RE: TECHNICAL REVIEW PROJECT# 21-04000011

Conditional Use - Giordano Residence - Parcel ID: 2401-502-0007-000-1

RE: Parcel ID: 2401-502-0007-000-1 Pre-Application Comments

SITE PLAN

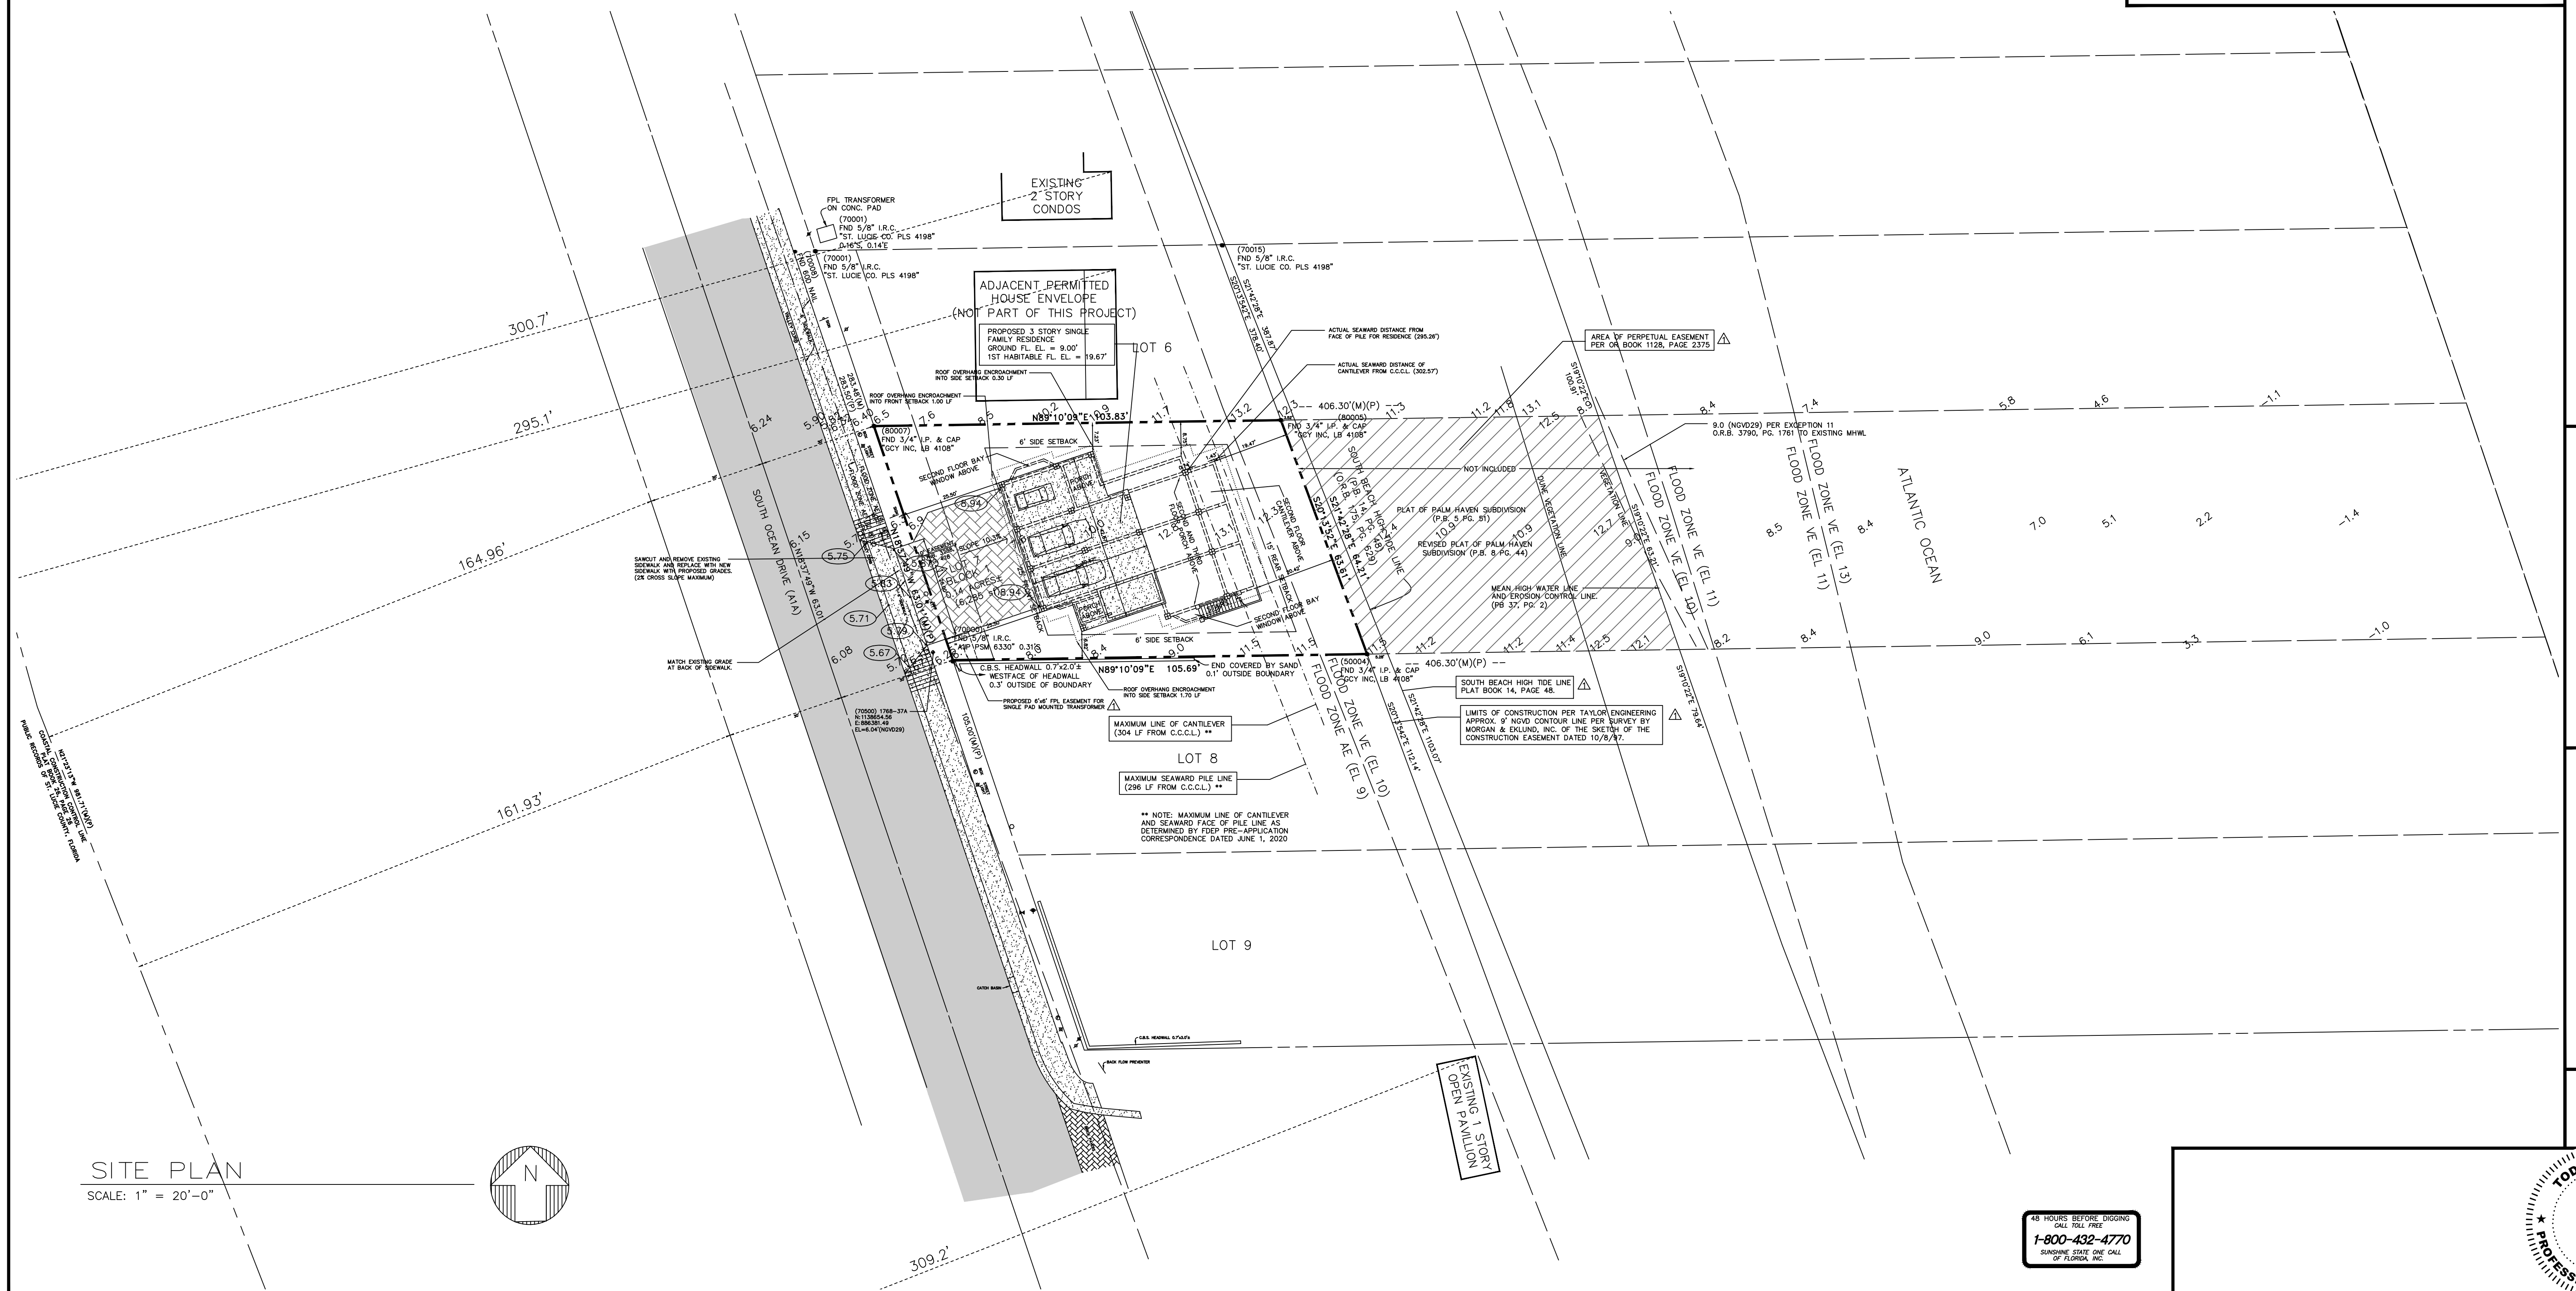
1. The driveway has been reduced to 26 ft. wide. See Page C-1 site plan.
2. Acknowledged. A FDOT driveway access permit and FDEP CCCL authorizing construction seaward of the construction control line will be submitted at the time of Building Permit.
3. We acknowledge that any above ground utility boxes, irrigation, royal palm trees and/or street lighting that conflict with the proposed driveway will be relocated at the owner's expense.

2. We acknowledge that electric service is available. A electric load requirement and CAD drawing will be provided at the time of building permit submittal. We have added a 6 ft. x 6 ft. utility easement on Page C-1 Site Plan for a single phase pad mounted transformer.

1. We have added the perpetual easement to Page C-1 Site Plan. Please be advised that this easement is outside of the subject property's boundary. The eastern property line of the parcel coincides with the established line by Taylor Engineering as per the recorded perpetual easement as provided to us by St. Lucie Co. Whereby, this project proposes no construction within the perpetual easement. We have discussed this with Joshua Revord. Enclosed are the deeds for the property and other pertinent deeds pertaining to this issue.
2. We acknowledge that the project requires a FDEP CCCL for construction seaward of the coastal control line. Page C-2 of the site plan showing a profile for the proposed residence shows the area of fill and excavation and that there will be no net loss of sand on the site.

SITE PROFILE

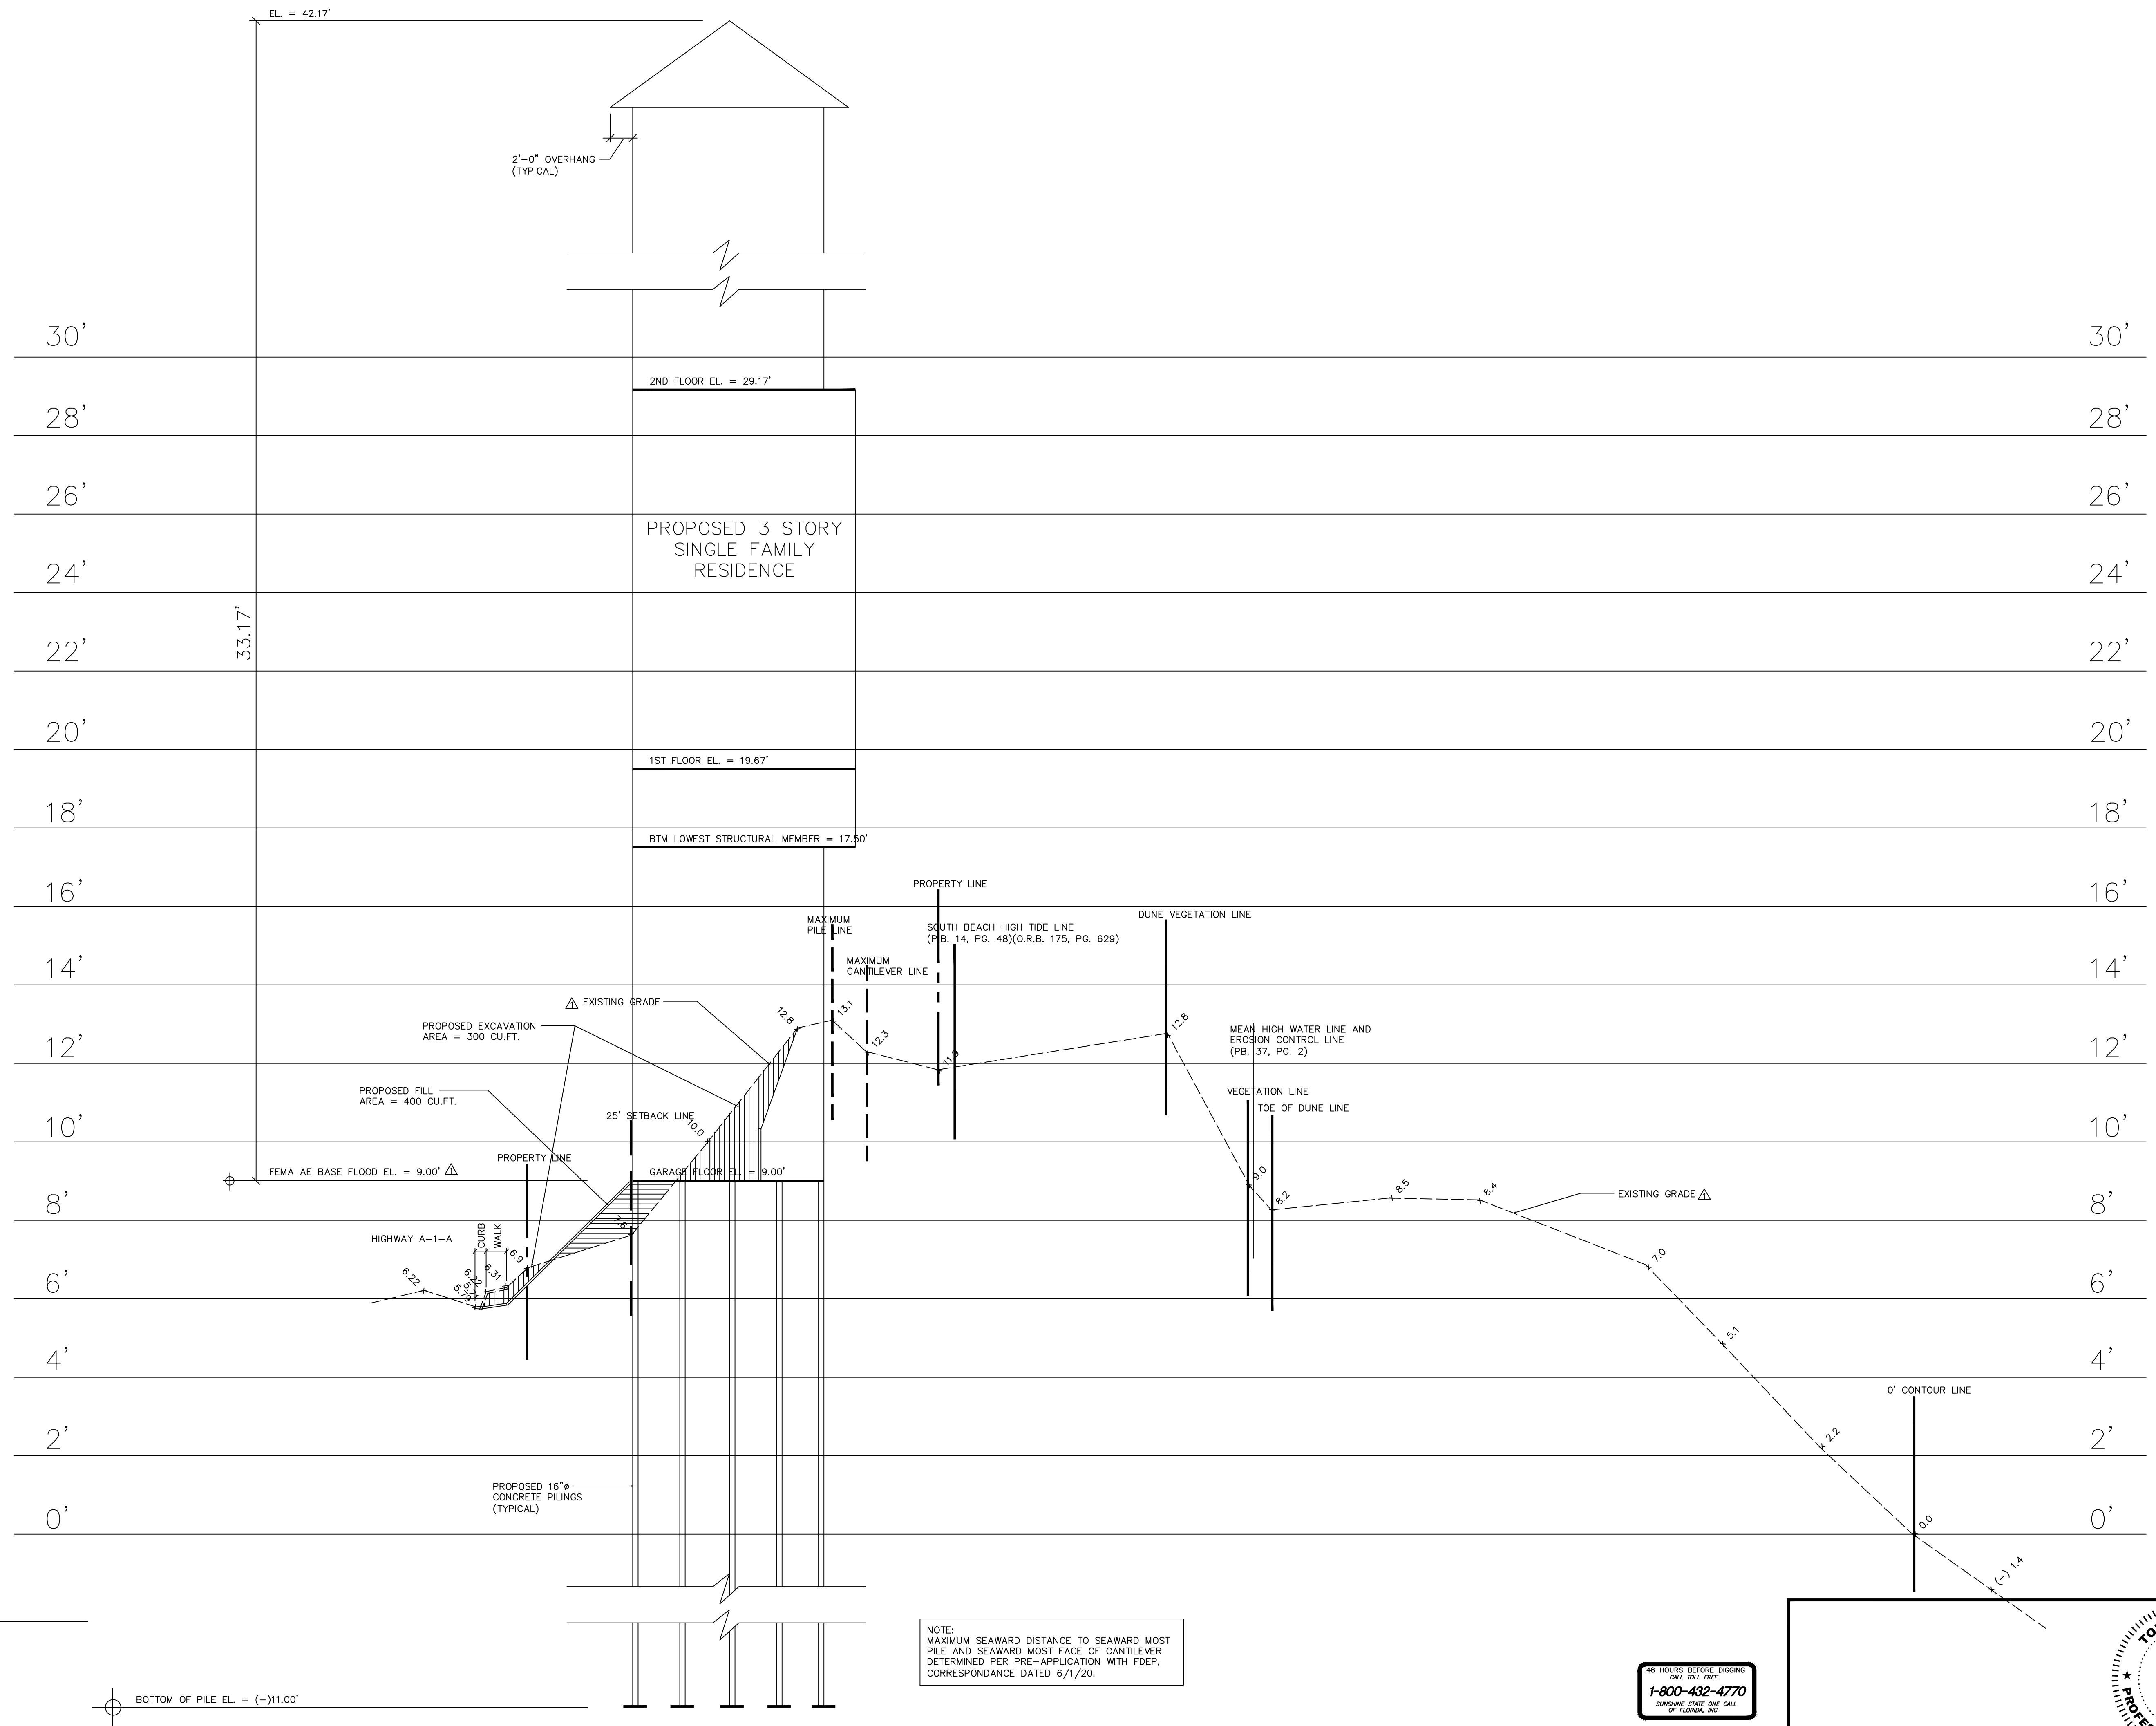
4. A design review application is enclosed.
5. An application for Development Review / Conditional Use with New Construction is enclosed.
6. The site plan profile height exhibit does show where the FEMA Base Elevation 9.0 and existing grade at the site and dimensions to peak of proposed residence.

NOTE:
 MAXIMUM SEAWARD DISTANCE TO SEAWARD MOST
 PILE AND SEAWARD MOST FACE OF CANTILEVER
 DETERMINED PER PRE-APPLICATION WITH TDEP,
 CORRESPONDANCE DATED 6/1/20.
